Product / Process Change Notification (PCN)

<p>PCN #: PCN_WIRL-PRO1_20190801</p> <p>Affected Series: WE-WIRL-PRO1; P/N 260701111100x</p> <p>PCN Date: July 01, 2019</p> <p>Effective Date: August 01, 2019</p>	<p>Change Category:</p> <p><input type="checkbox"/> Equipment / Location <input checked="" type="checkbox"/> General Data <input type="checkbox"/> Material <input type="checkbox"/> Process <input type="checkbox"/> Product Design <input type="checkbox"/> Shipping / Packaging <input type="checkbox"/> Supplier <input type="checkbox"/> Software</p>
<p>Contact: Product Management</p> <p>Phone: +49 (0) 7942 - 945 5001</p> <p>Fax: +49 (0) 7942 - 945 5179</p> <p>E-Mail: pcn.eismart@we-online.com</p>	<p>Data Sheet Change:</p> <p><input checked="" type="checkbox"/> Yes <input type="checkbox"/> No</p> <p>Attachment:</p> <p><input type="checkbox"/> Yes <input checked="" type="checkbox"/> No</p>

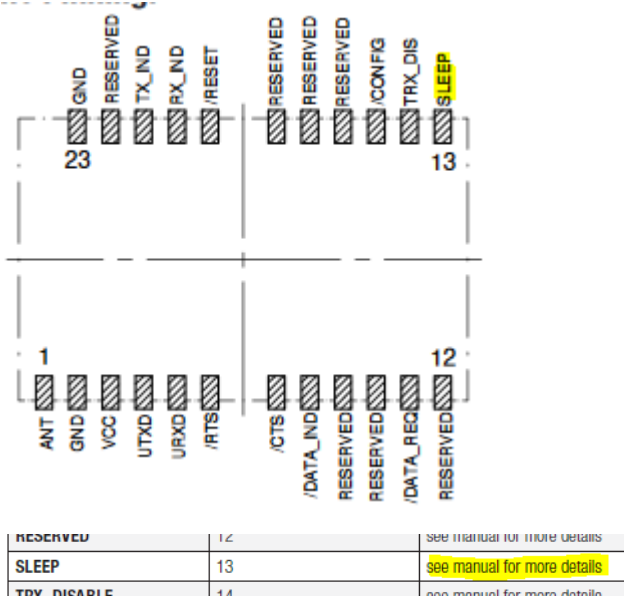
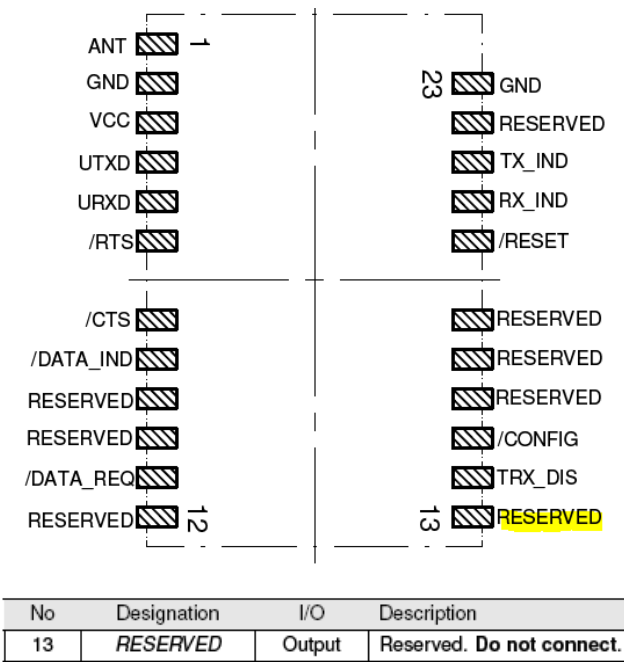
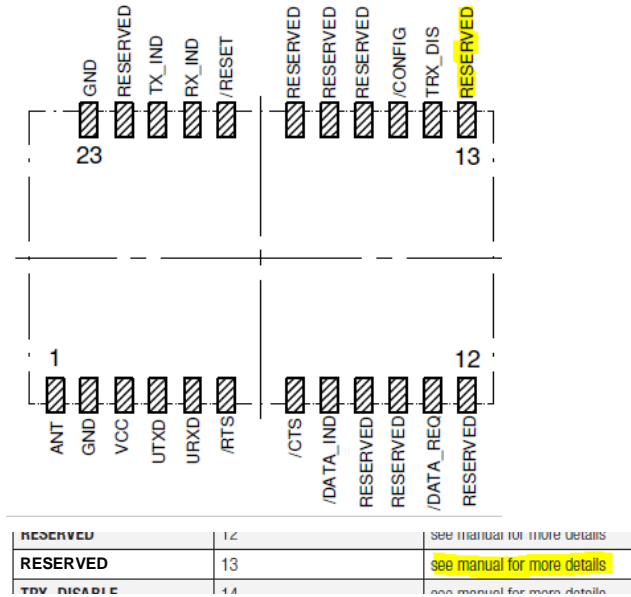
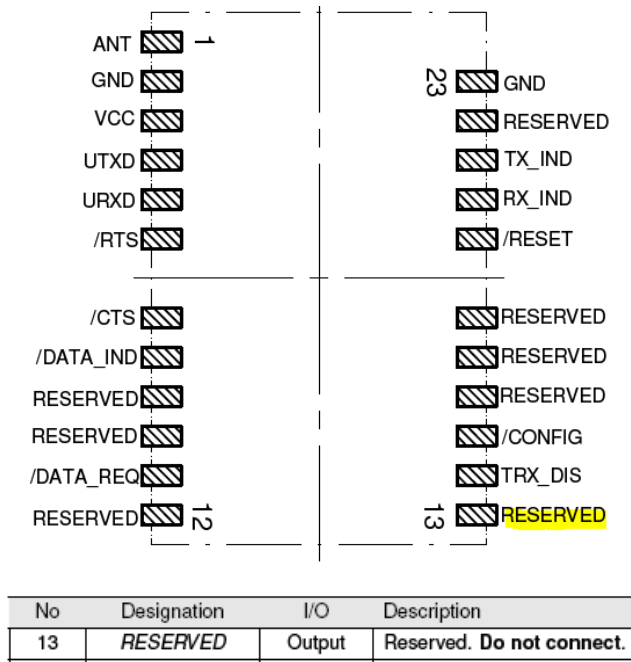
Because of a database mismatch, Würth Elektronik will correct the datasheet.
All products since market launch, are affected by this change.
There will be no change in form, fit, function, quality or reliability of the product.

Pin 13 of the module was named as sleep pin but pin 13 is reserved for functions not yet implemented. Through the description in the product manual the pin function was explained correctly.
Even with the correct information in the user manual and the note in the datasheet that the user manual is binding a PCN information is created to explicitly inform customers and avoid errors in the design in phase.
